Meeting Date: Tuesday 21 July 2015
Location: Committee Room 2, Level 5, Civic Centre, 1 Devlin Street, Ryde
Time: 5.00pm

Item		Page
1	CONFIRMATION OF MINUTES - Meeting held on 16 June 2015	1
2	37 PENNANT AVENUE, DENISTONE. LOT 1 DP 1005675. Local Development Application for Demolish pool, subdivide land into two lots, erect a new two storey dual occupancy with strata subdivision on one lot and retain the heritage item and outbuildings on the other lot. LDA2015/0005.	7
3	120-124A VICTORIA ROAD, GLADESVILLE. LOTS 1 and 2 DP 552766 and LOT A DP 439417. Local Development Application for construction of a six storey residential flat building with forty six (46) apartments and basement parking containing fifty six (56) car parking spaces. LDA2014/0379.	173

The proposal involves a two (2) lot subdivision and strata subdivision of a two (2) storey dual occupancy on one (1) lot and retention of the heritage item and outbuildings on the other lot.

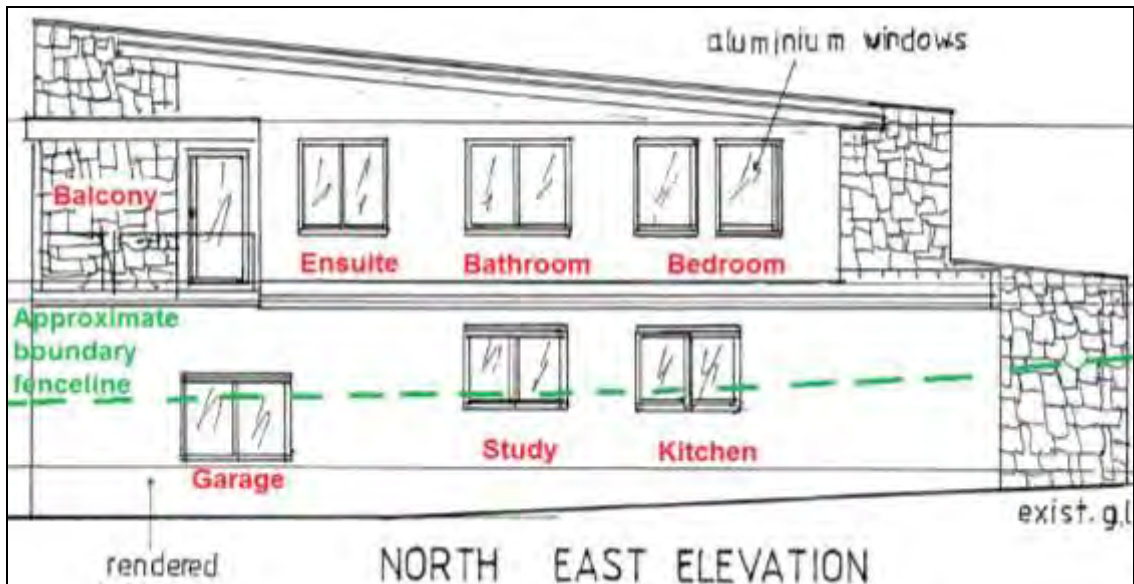
The following plan extract identifies tree species to be retained and removed along the north-eastern side boundary which offer privacy to adjoining properties:

Trees to be removed are located in the front yard and front portion of the proposed dual occupancy. Overlooking from the proposed front yard would be minor as it is not the private open space area of the proposed dual occupancy. It is considered that tree removal will not compromise the privacy enjoyed by neighbouring properties however, the proposed siting and design of the dual occupancy will adversely impact this existing level of privacy.

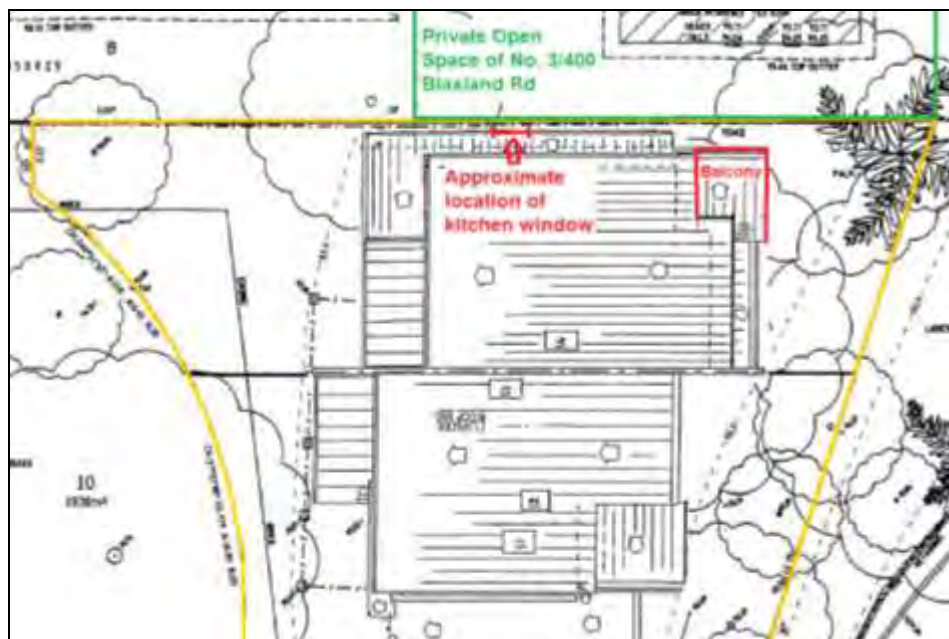
The windows featured within the north-eastern elevation raised as a concern by adjoining properties are shown below:

Windows within the north-eastern elevation on the first floor relate to a bedroom, bathroom, ensuite and a balcony orientated towards Pennant Ave. It is acknowledged that a kitchen window exists on the ground floor however; the fence line would only obscure a small portion of the window. This window correlates with the private open space of No. 3/400 Blaxland Rd. Further, the balcony on the first floor overlooks the side passage of this adjoining property as illustrated below:

These issues have not been raised to the applicant in light of heritage issues, however, mitigation measures including fitting a privacy screen to the north eastern side of the balcony, fitting lattice screening to the top of the boundary fence or amending the size or style of the kitchen window could be taken to rectify concerns in relation to privacy, if it is decided to approve the DA.

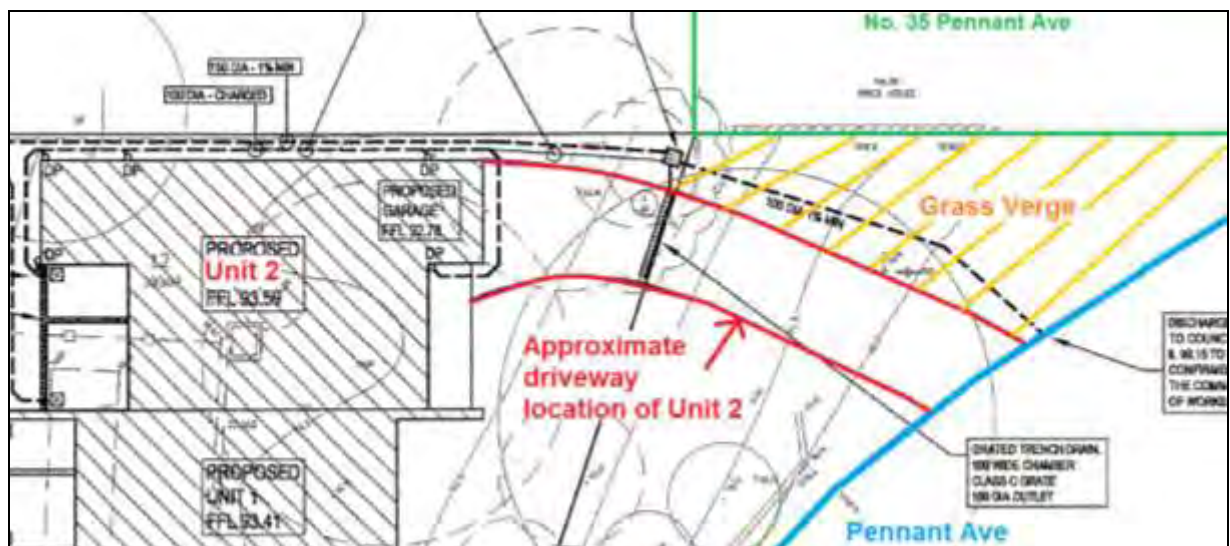
- B. *Parking.*** Concerns are raised that the proposed location of the dual occupancy will encourage vehicles to park on the grass verge in front of No. 35 Pennant Avenue.

The portion of the land to which this concern relates is shown below:

The grass verge in this location is actually part of the road reserve (i.e. footpath) and therefore parking of vehicles on the 'verge' would not be lawful under NSW Road Rules. If this 'verge' were to be used for such vehicle parking then Council's Parking Enforcement Officers would have powers under the relevant legislation to take appropriate enforcement action.

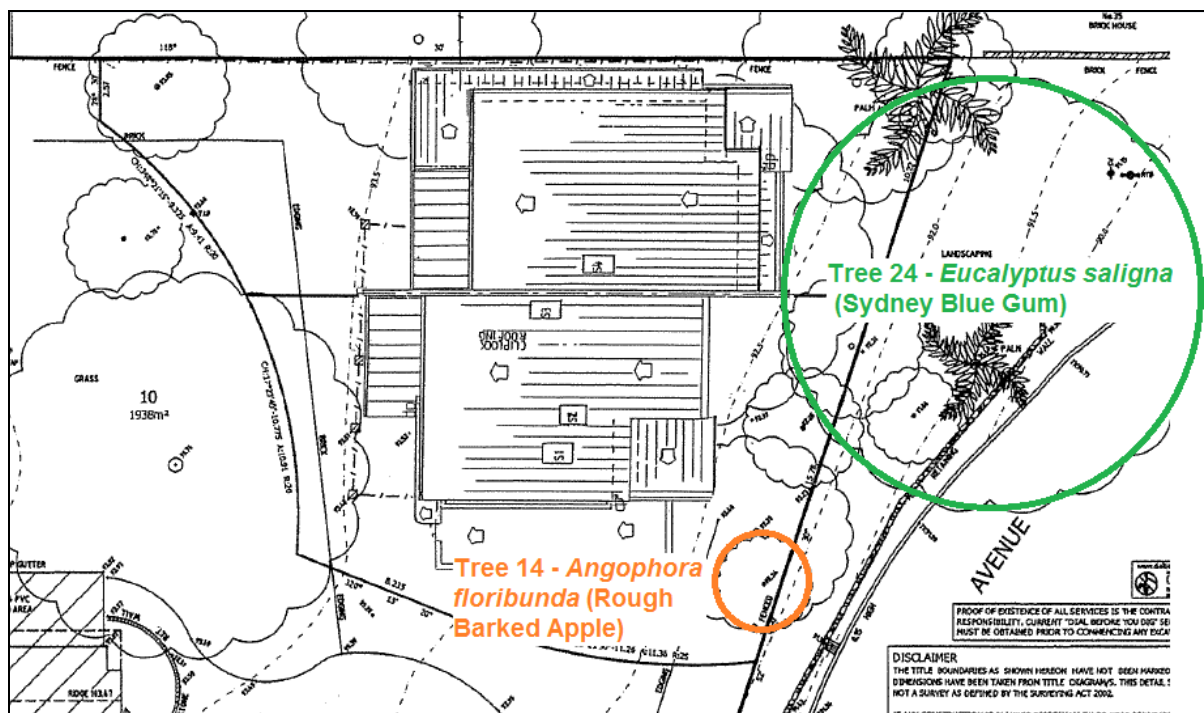
It is noted that the driveway to Unit 2 is proposed in this location to ensure a Sydney Blue Gum tree situated along the proposed lot's front boundary can be retained.

There are two (2) significant trees on the proposed lot – namely a Sydney Blue Gum and also a Rough Barked Apple tree. These are shown in the following plan extract:

Council's Consultant Landscape Architect has noted that the applicant proposes to retain these trees however; there is presently insufficient information to determine the level of impact on these trees. This information would normally be required however given the heritage concerns with this DA the applicant has not been requested to provide this information.

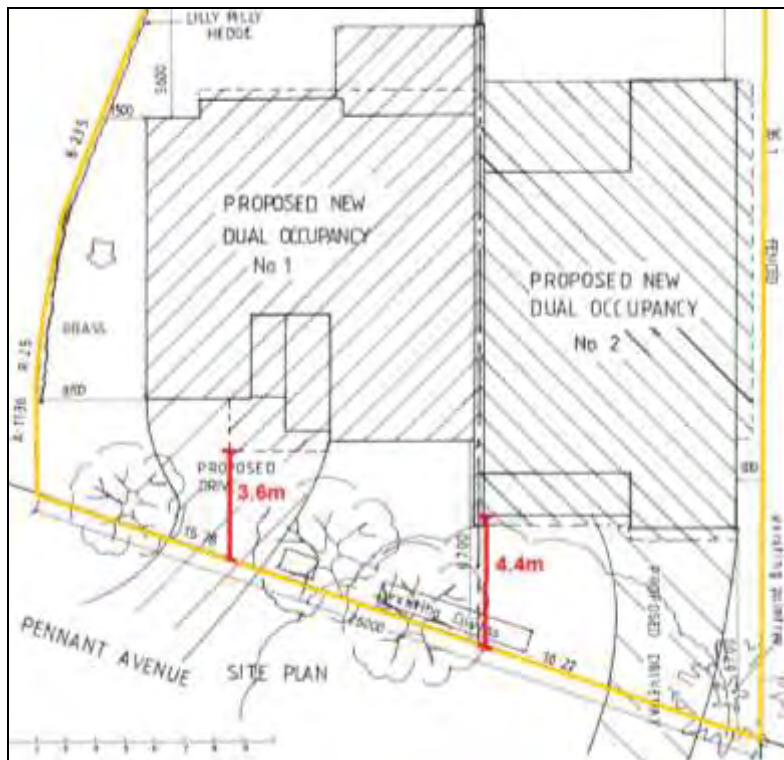
A. Front Setbacks – Section 2.9.1 (a)

“Dwellings are to be set back 6m from the street front boundary.”

A front setback of 3.6m is proposed to unit 1, measured to the first floor balcony and representing a non-compliance of 2.4m (40%). A front setback of 4.4m is proposed to unit 2, measured to the front porch and representing a non-compliance of 1.6m (26.6%) as shown in the following plan extract:

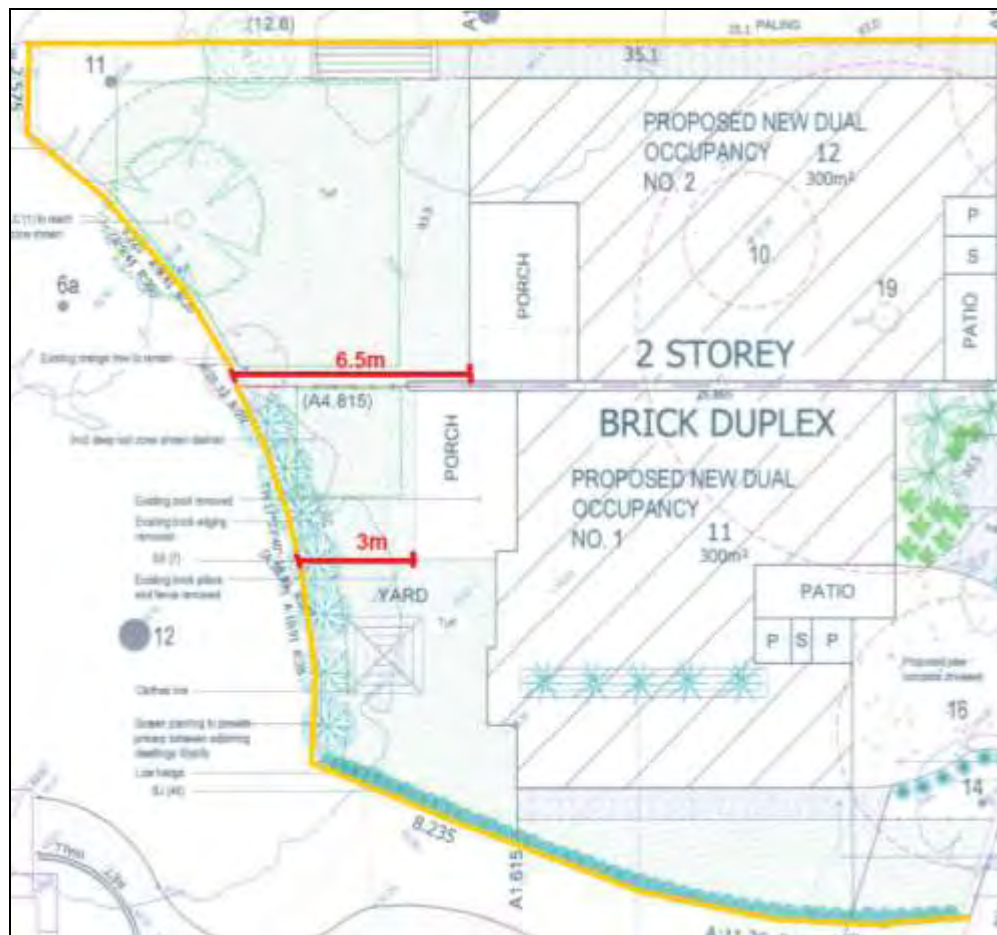
The following plan extract identifies this non-compliance:

This balcony occupies an area of 12m². There is scope for this balcony to be reduced in width to comply with the side setback control without impinging on its functionality as a space.

This non-compliance can be addressed via a condition of consent should the issues pertaining to heritage be resolved if it is decided to approve the DA.
